Project Name: Clinton Softball Concessions Building
WBA Project Number: 26-010

ADDENDUM NO. 03

1 TRANSVERSE SECTION 02
1/4" = 1'-0"

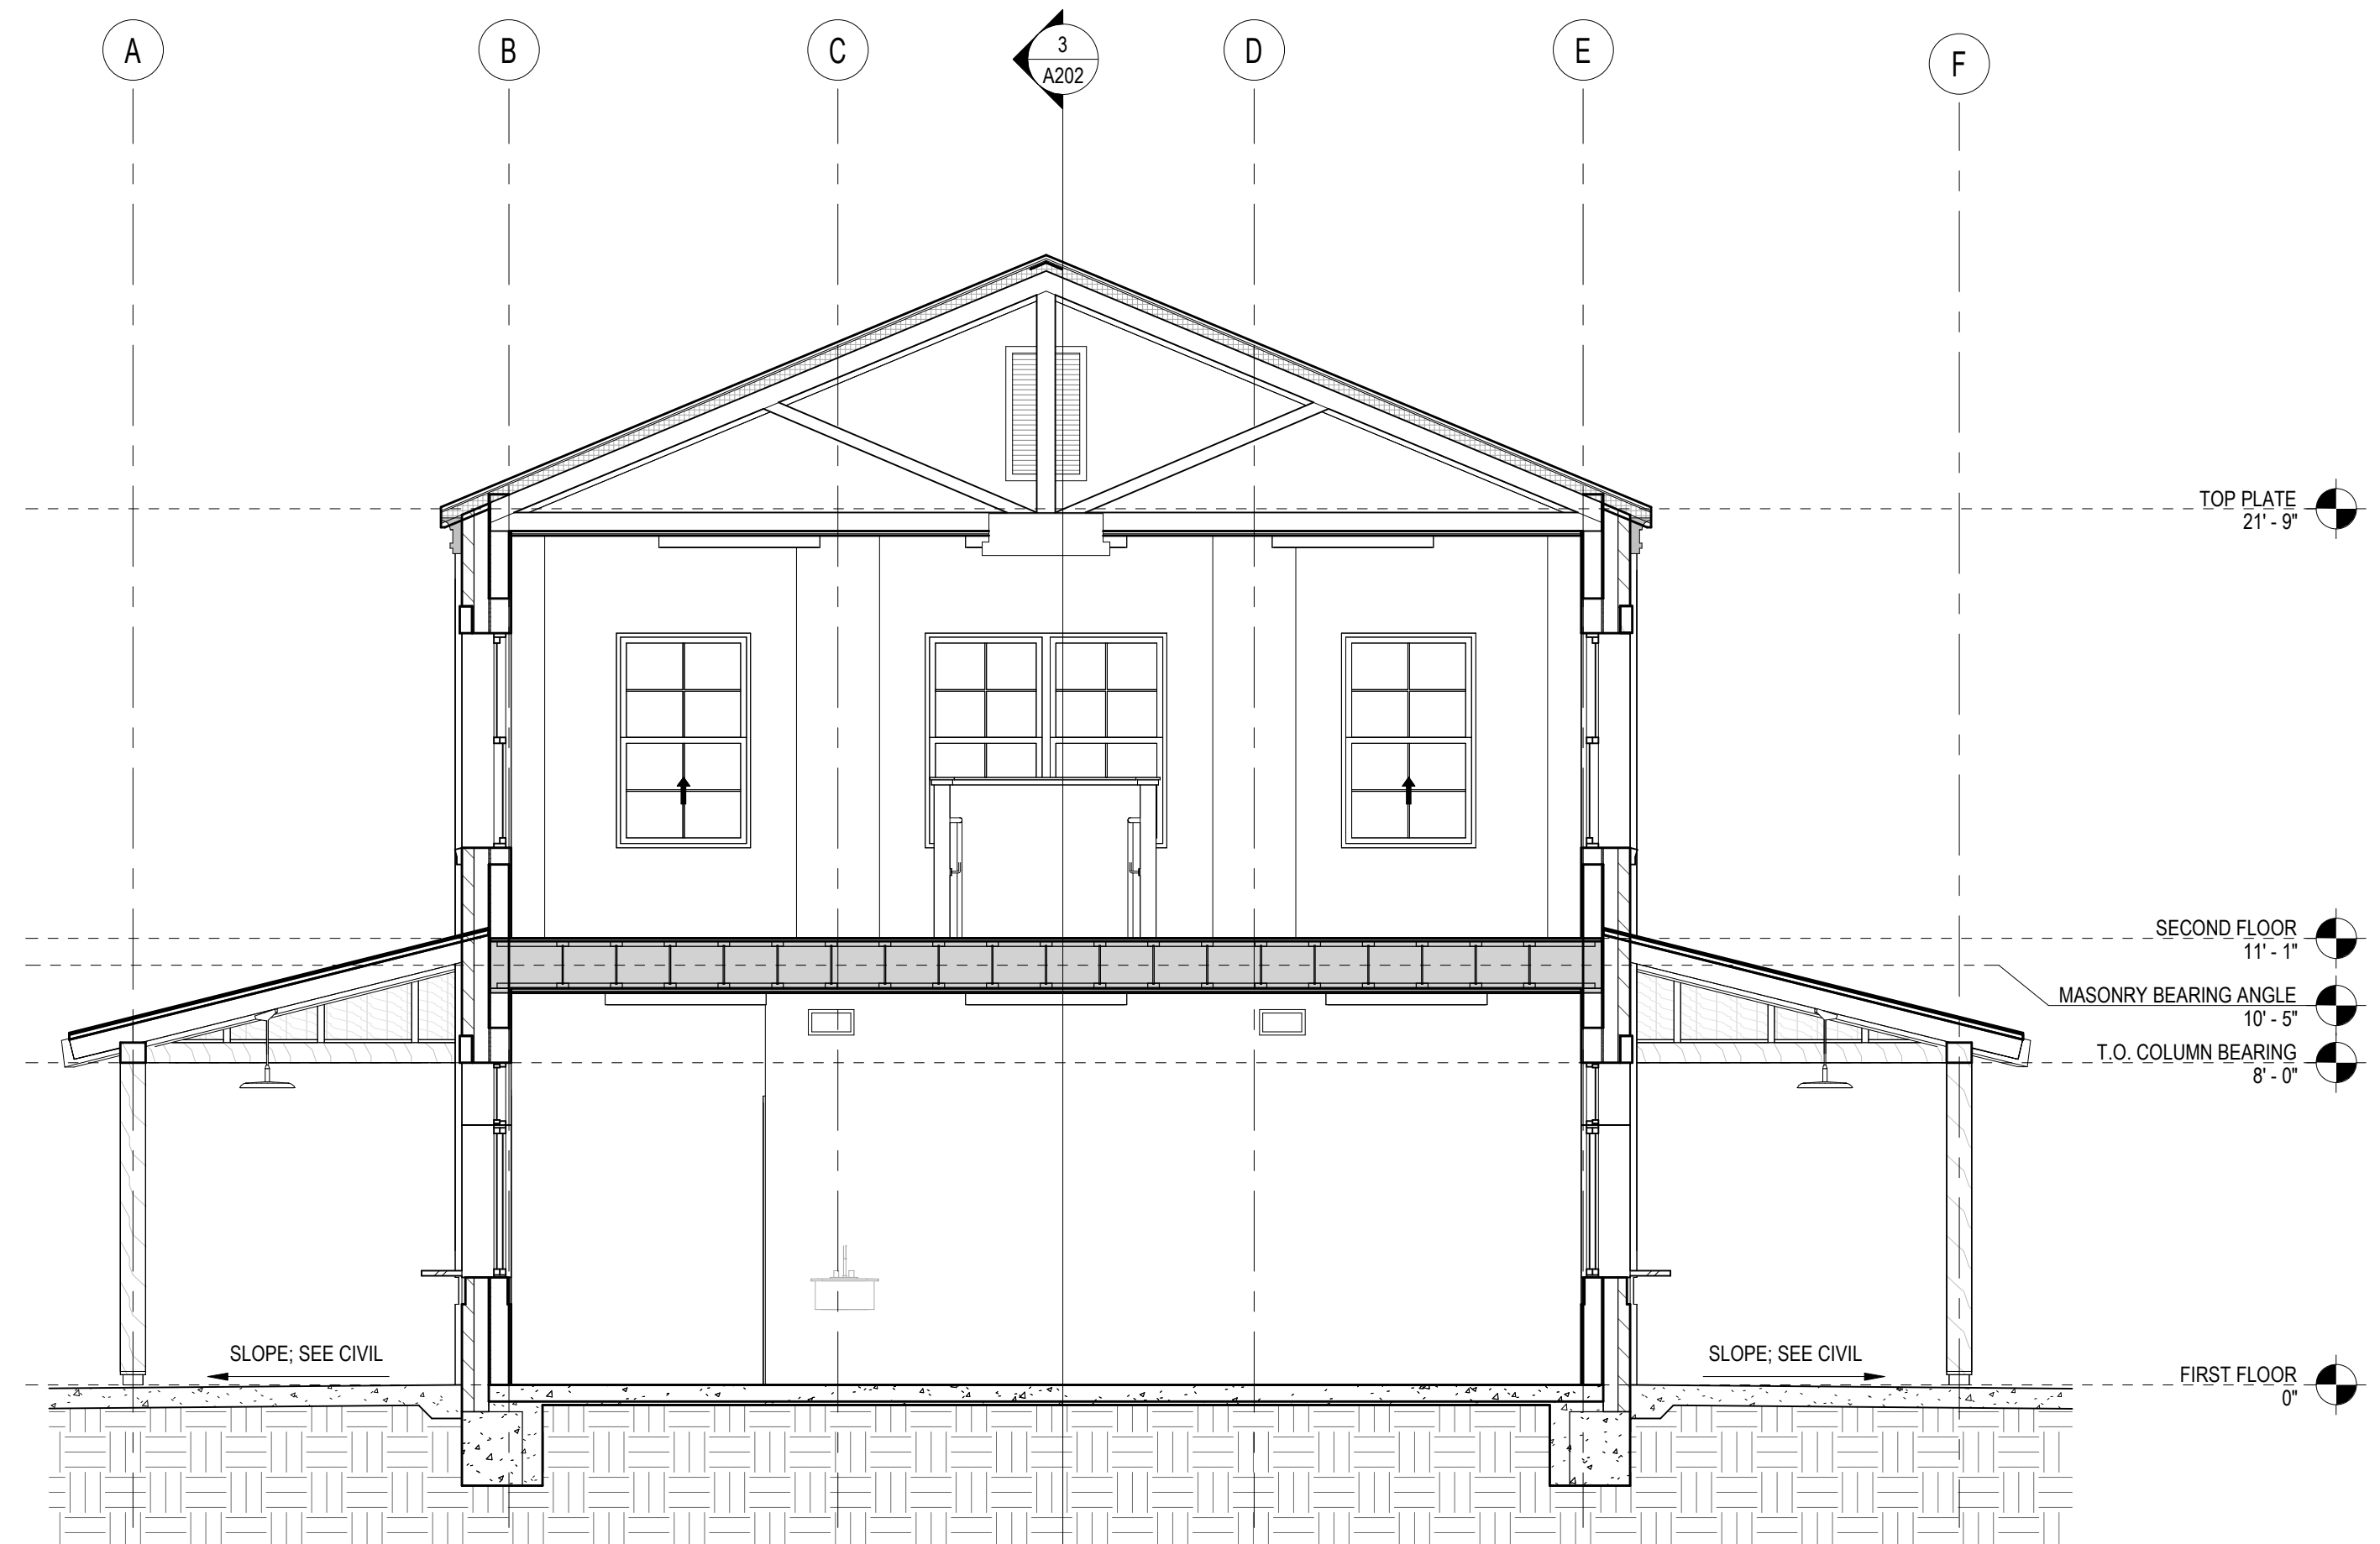
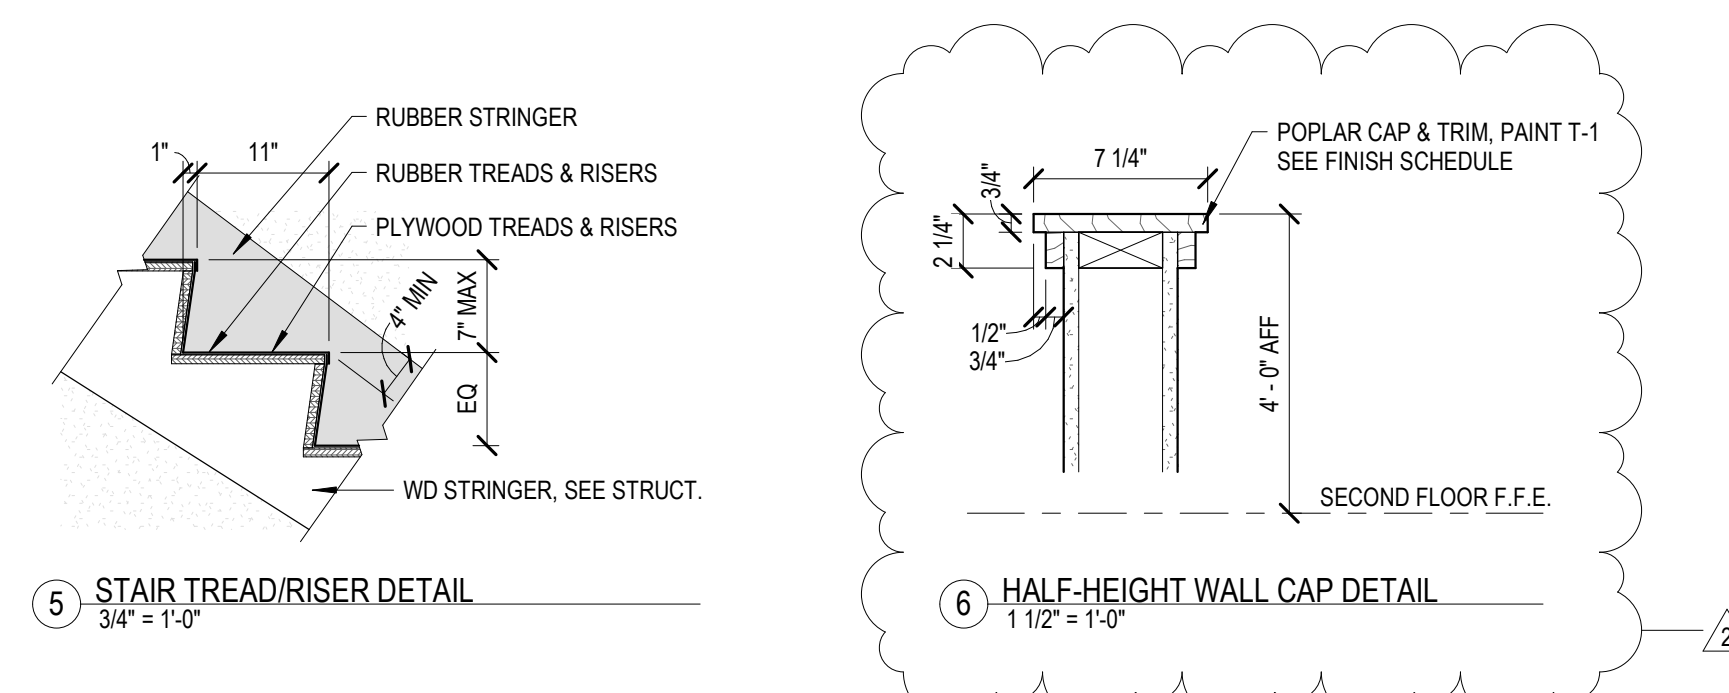
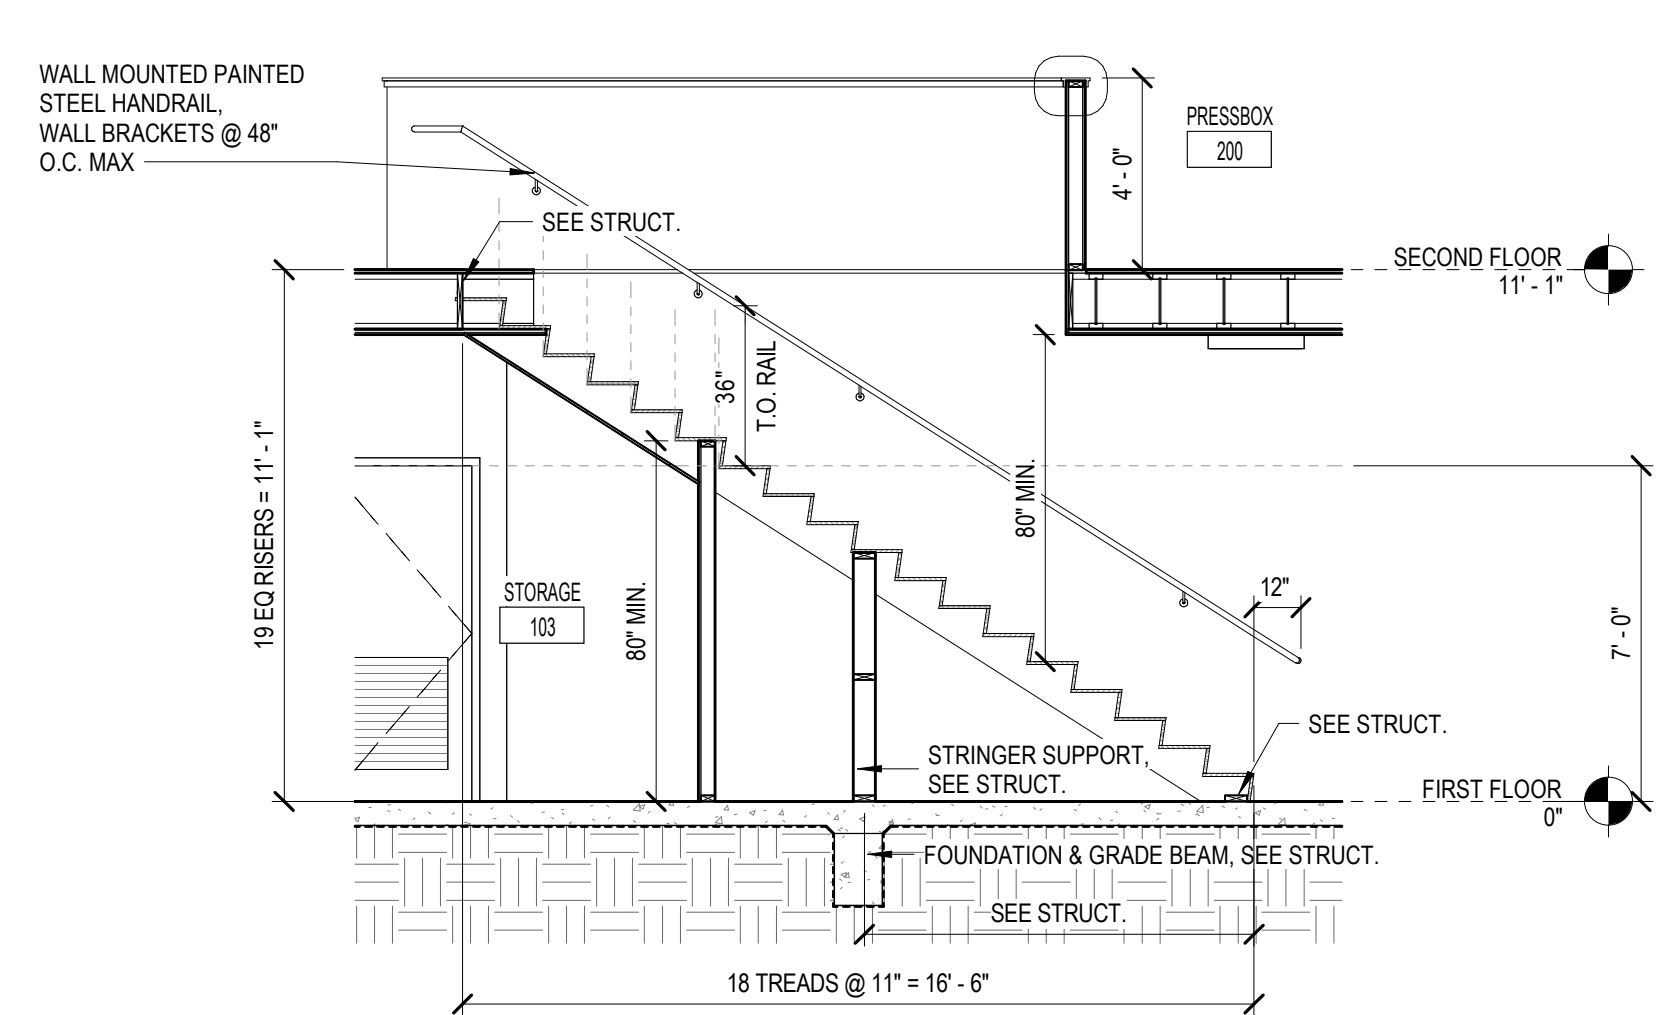
- ITEM NO. 11 Delete and replace A202 in its entirety. Dimensions revised for painted trim.

1 WALL SECTION 01
3/4" = 1'-0"

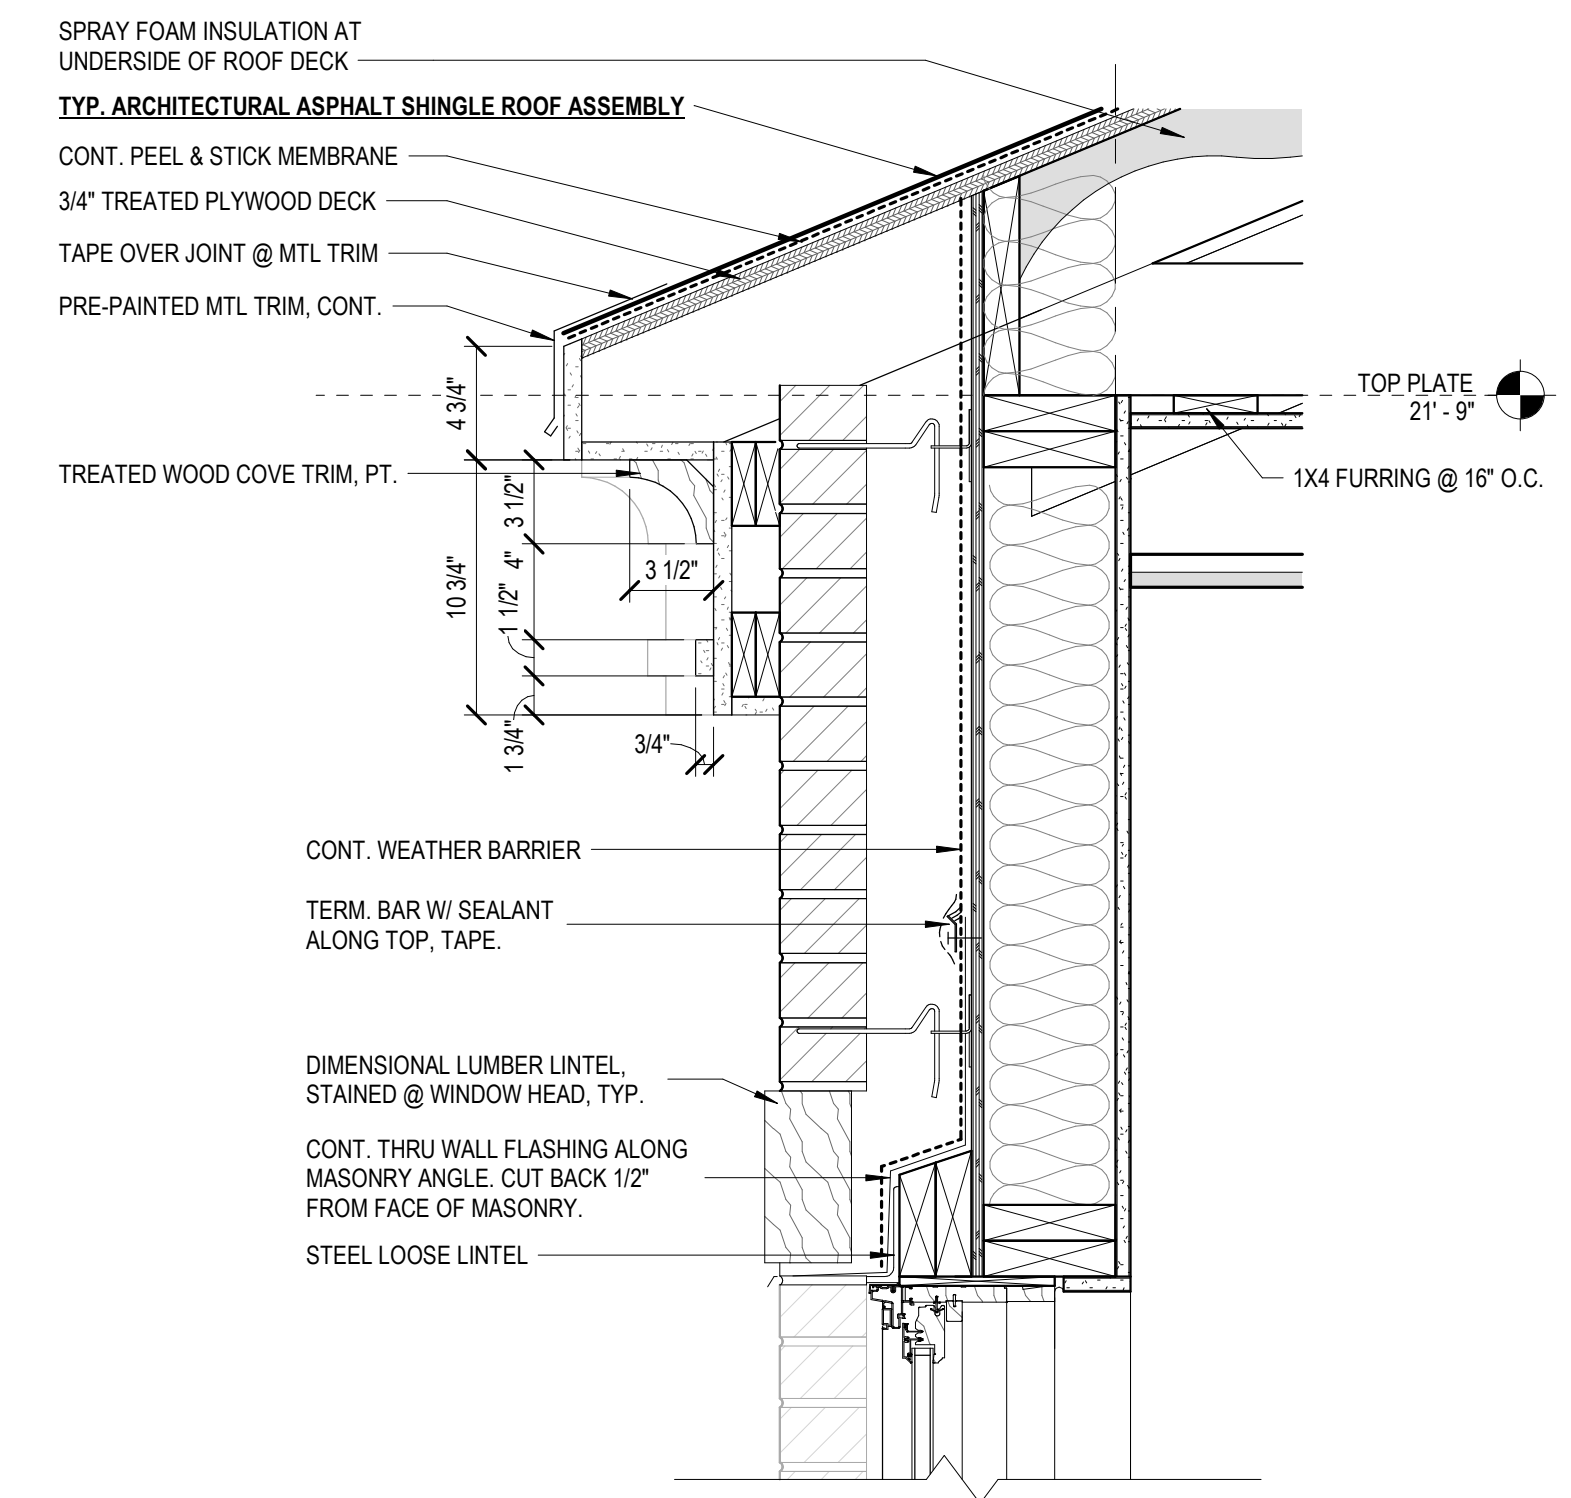
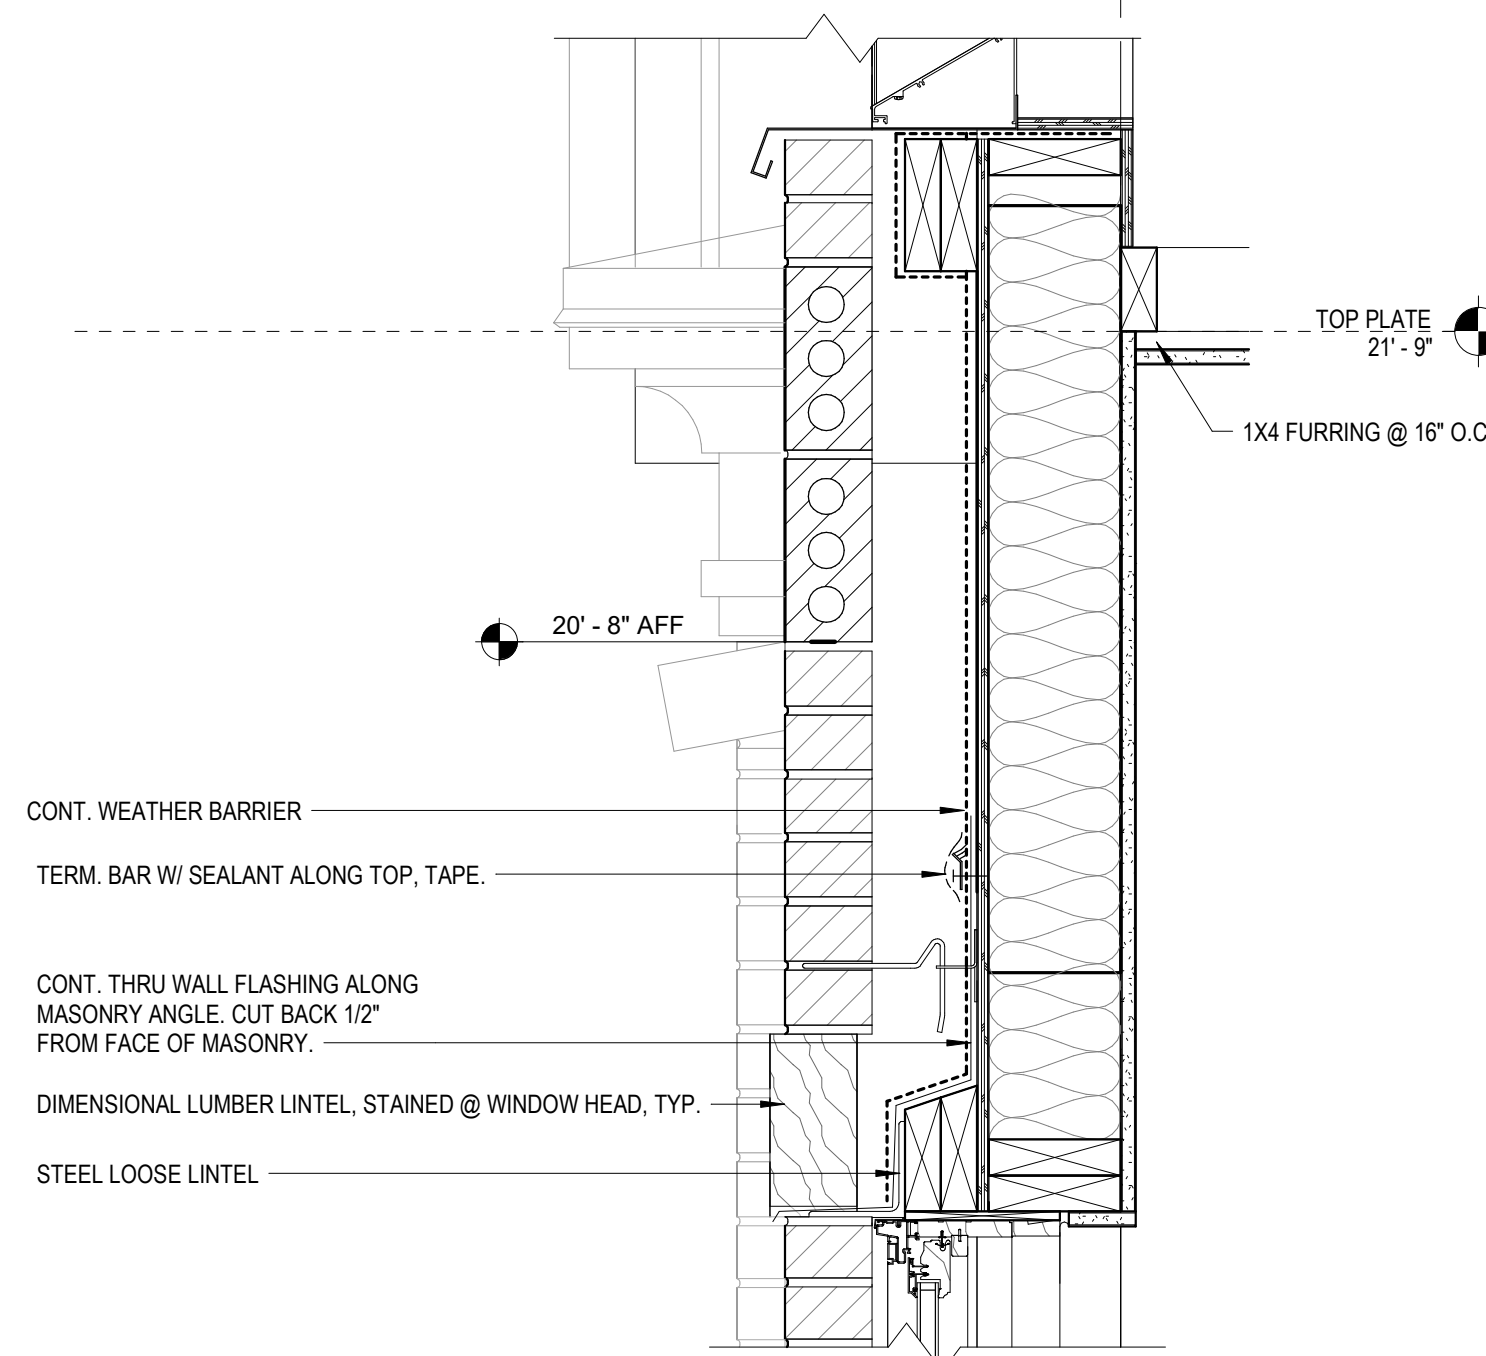
- ITEM NO. 12 Delete and replace A301 in its entirety. Asphalt Shingle Roof Assembly has been updated.
- ITEM NO. 13 Delete and replace A401 in its entirety. Detail notes have been revised.
- ITEM NO. 14 Delete and replace E000 in its entirety. Canopy lighting revised.
- ITEM NO. 15 Delete and replace E100 in its entirety. Canopy lighting revised.
